SITE PLAN APPROVAL

114.41
 Henry Rifle Ln

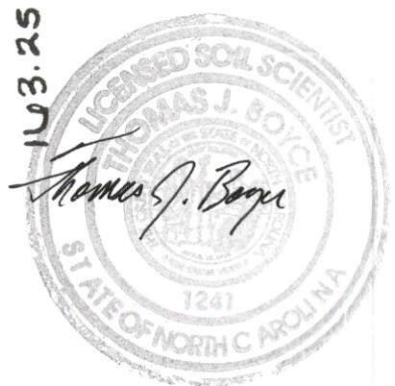
-- Existing Drain Lines
 Repair Area may be
 LPP at .15 IIR
 2400 ft² required
 over 2700 ft² shown
